1.3 31-33 HIGH STREET ROAD, ASHWOOD - USE AND DEVELOPMENT OF LAND FOR THE PURPOSE OF A FOUR STOREY MEDICAL CENTRE, THE REMOVAL OF TWO RESTRICTIVE COVENANTS, DISPLAY OF SIGNAGE, REMOVAL OF VEGETATION AND ALTERATION OF ACCESS TO A TRANSPORT ZONE SCHEDULE 2 (TPA/54467)

EXECUTIVE SUMMARY:

The proposal is considered inconsistent with the relevant provisions of the Monash Planning Scheme and it is recommended that the application be refused.

Advertising Signs

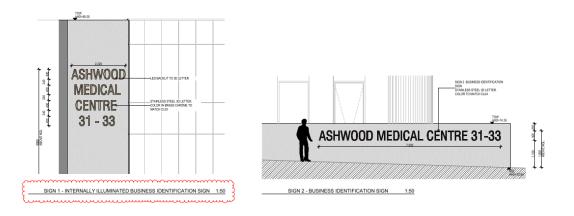
Except for a direction sign (for which no permit is required), the proposed signs are all facing High Street Road.

An internally illuminated business identification sign detailing the name of the centre and the site address is proposed on the wall of the building facing south-

west along High Street Road. It will measure 2.2 metres by 2.3 metres and have a maximum height above ground level of 9.5 metres.

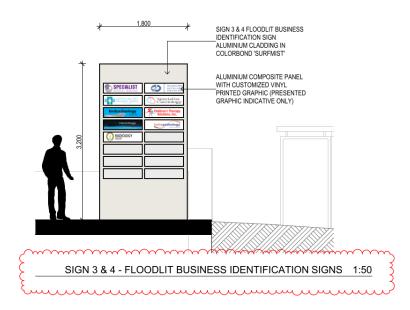
One business identification sign made of stainless steel 3D lettering will also specify the name of the centre and the site address and be located on the planter wall facing south. It measures 7.5 metres long by 400mm high.

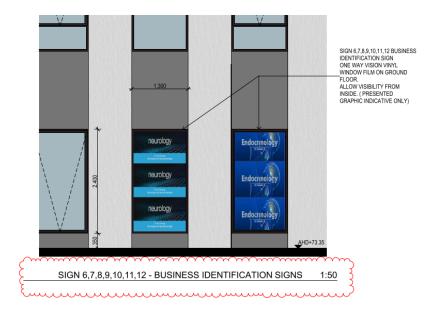
There are two blades (floodlit business signs) measuring 3.2 metres high by 1.8 metres wide containing the names of the specialists. These will be located at either end of the building within the front setback.

Each of the seven windows facing the street at ground level will be fitted with one way vision vinyl, also with the names of the specialists on them (business identification signs). These are each 2.4 metres by 1.3 metres in size.

DWG NO: TP201

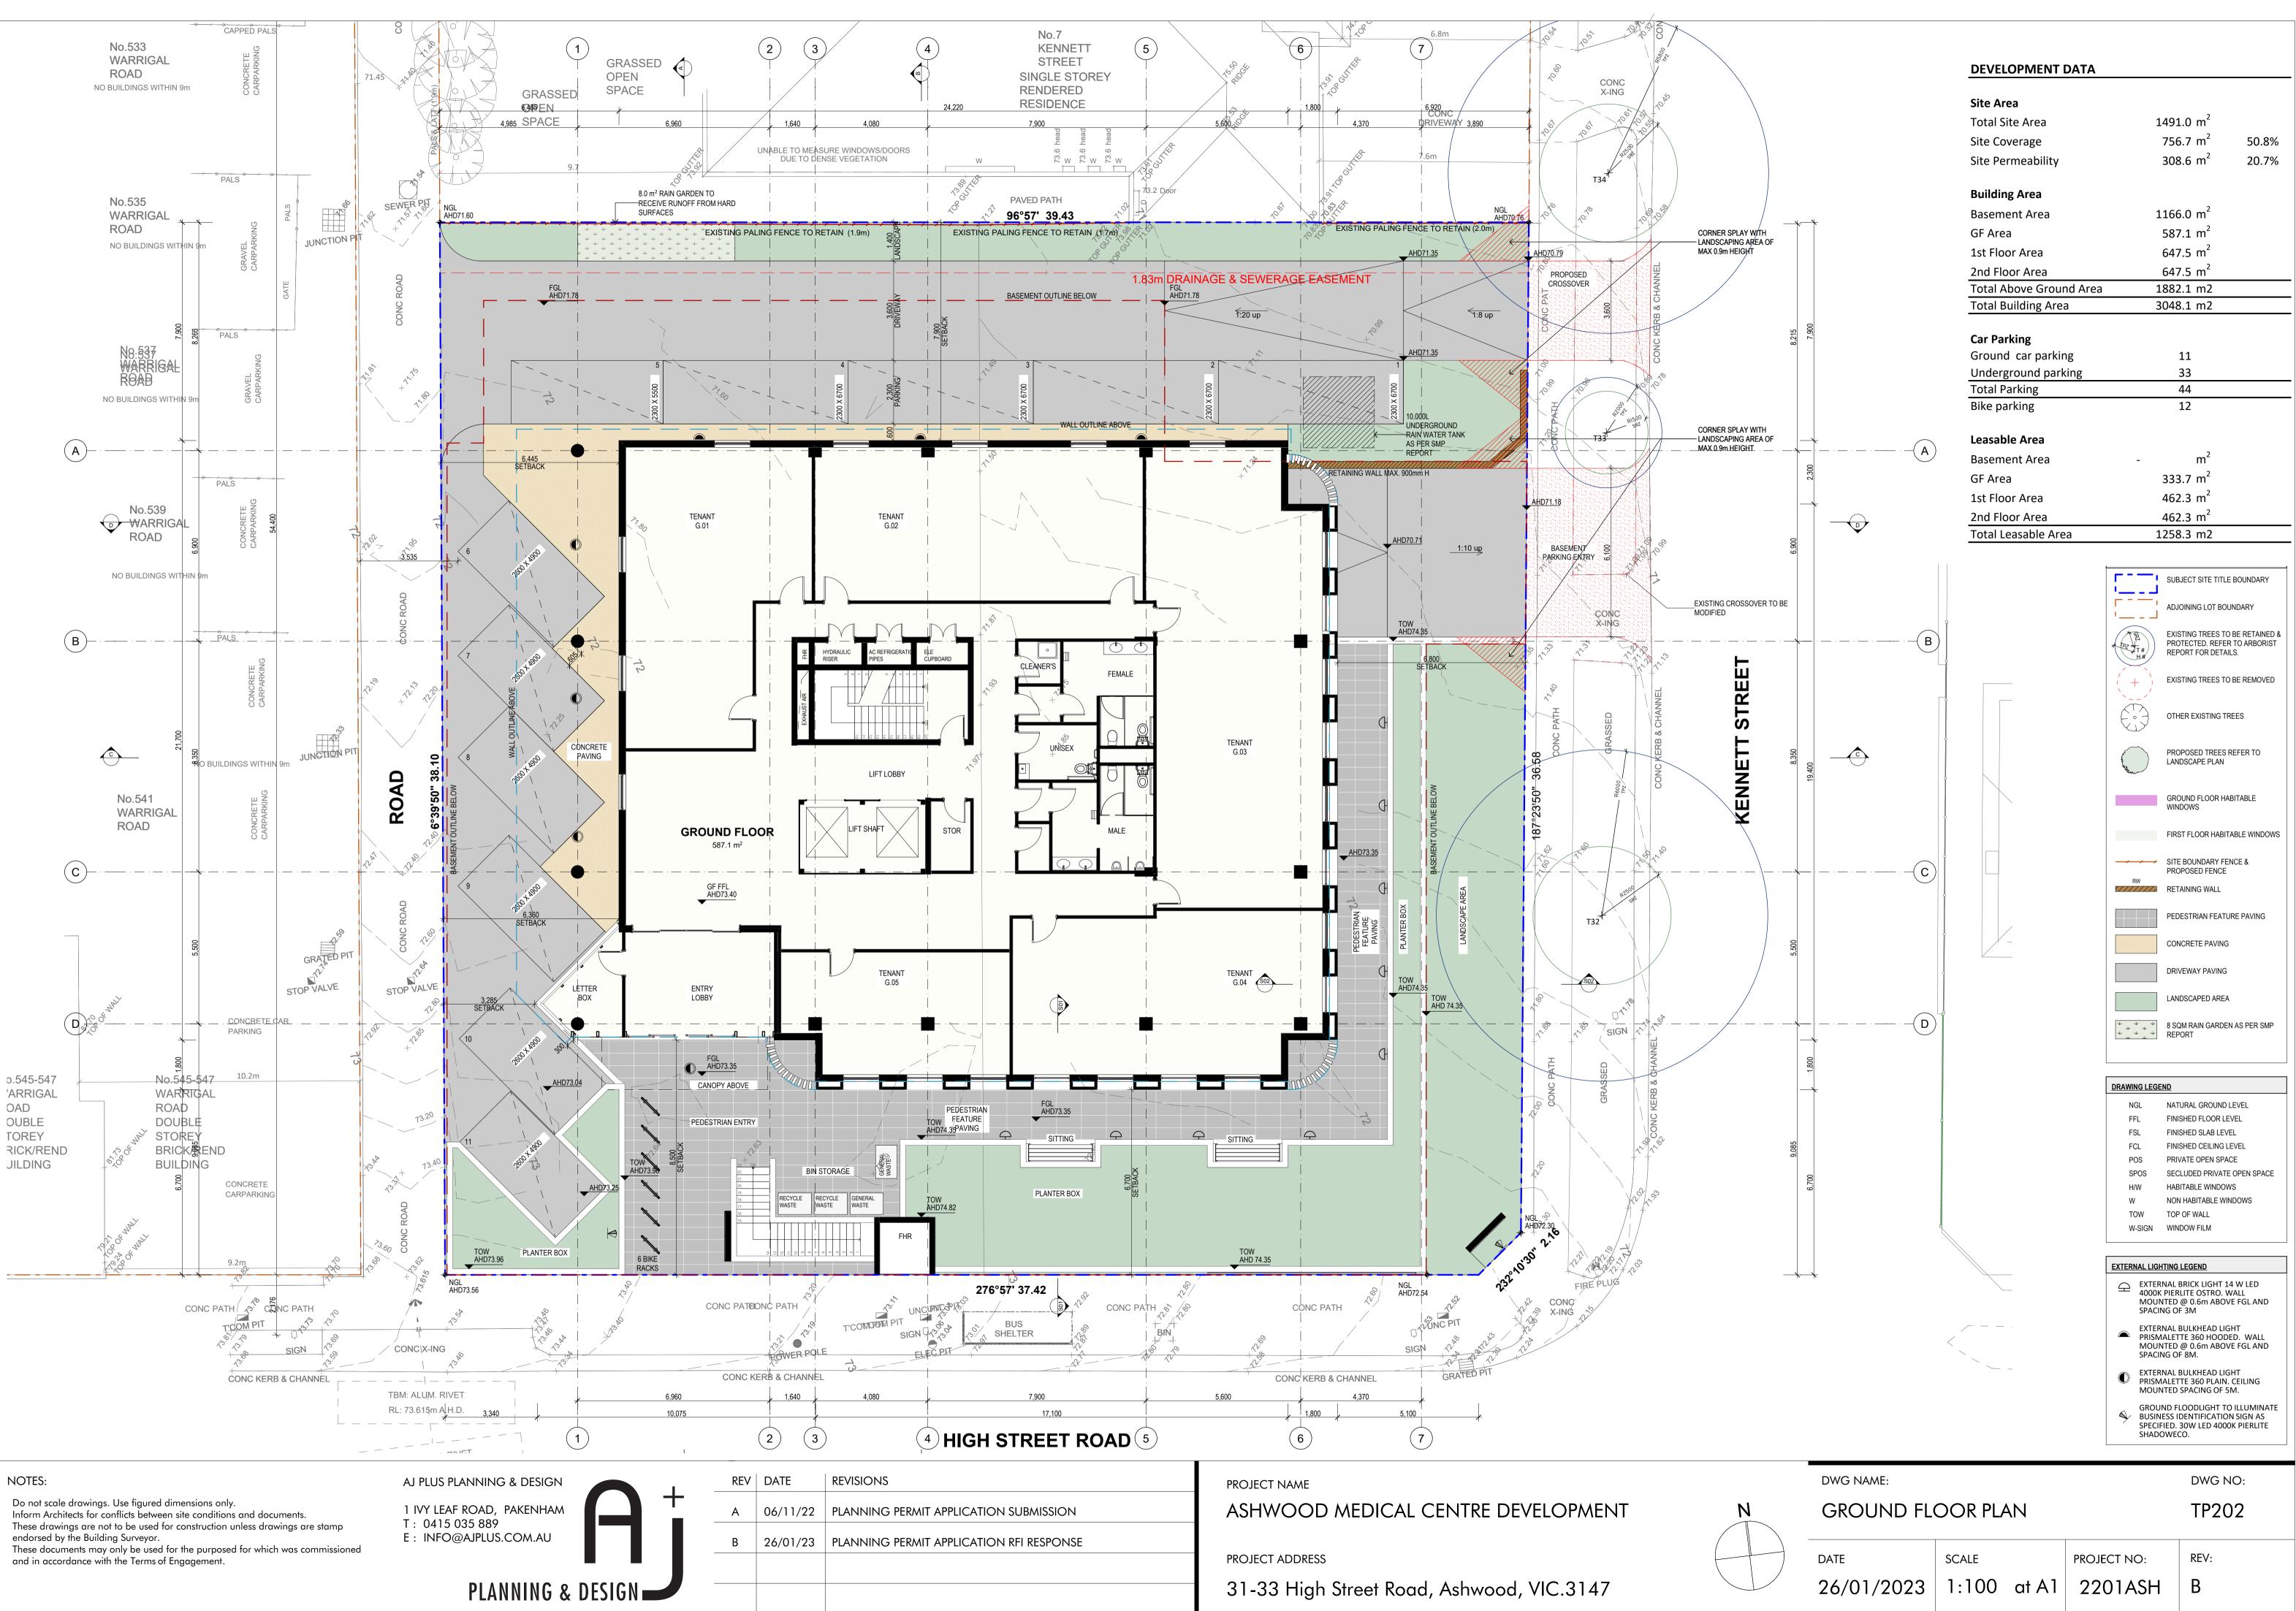
- The proposed basement car park layout is poor, with 8 sets of tandem spaces. The assignment of all these spaces (16 spaces) to staff would assign insufficient spaces to patients, who are unlikely to accept the alternative of parking off the laneway due to the potential of being blocked in. The provision of assigning the front space to patients would mean that staff would not be able to exit in an emergency or if attending outside appointments etc. The use of tandem spaces in either case is problematic and should be avoided.

- The southern section of the basement carpark shows one-way circulation only. A vehicle travelling southbound in the eastern access aisle is likely to ignore the one-way arrows and travel west to circulate the carpark which is likely to cause vehicle conflict issues.
